Modification of the Deflector

(TM7011 / 2)

Deflector with edge protector:

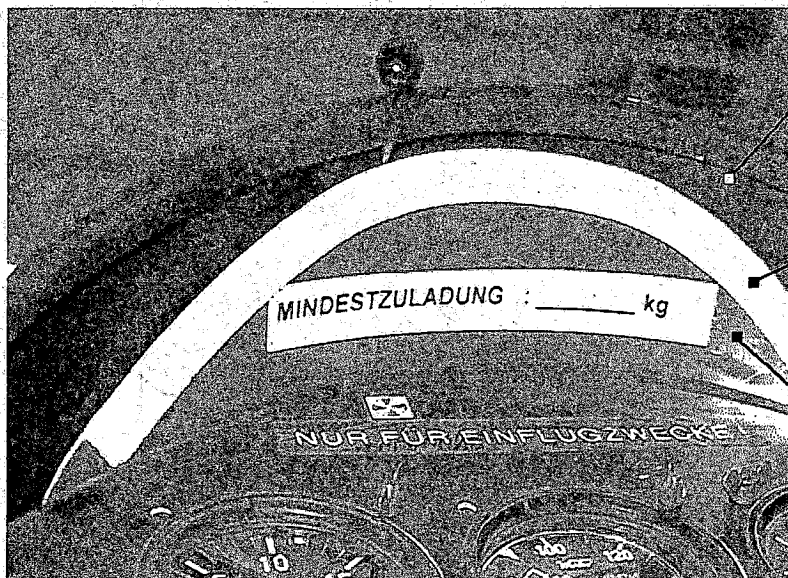
1. Drill blind rivets. If need be, unscrew upper instruments (Hexagon head 2.5 mm und ratchet with 7mm socket) and place them on top of the second row.
2. Mark new fixing holes 10mm (0.4 in) offset from originals and drill. This enables to use the existing holes at the instrument panel edge.
3. Shorten straight edge of deflector by 10 mm, soften edge and paint black. Maximum depth of deflector after trimming is 100 mm (3.94 in).
4. Rivet deflector back to top of instrument panel, facing towards the pilot (Blind rivets \varnothing 4mm*6.5, large washers \varnothing 4.3 * 12 * 1mm DIN 9021-St).
5. Push edge protector (as long as instrument panel allows) onto deflector edge.

Should the instrument panel cover be too short to allow the protector to fit underneath, contact manufacturer stating model and serial number.
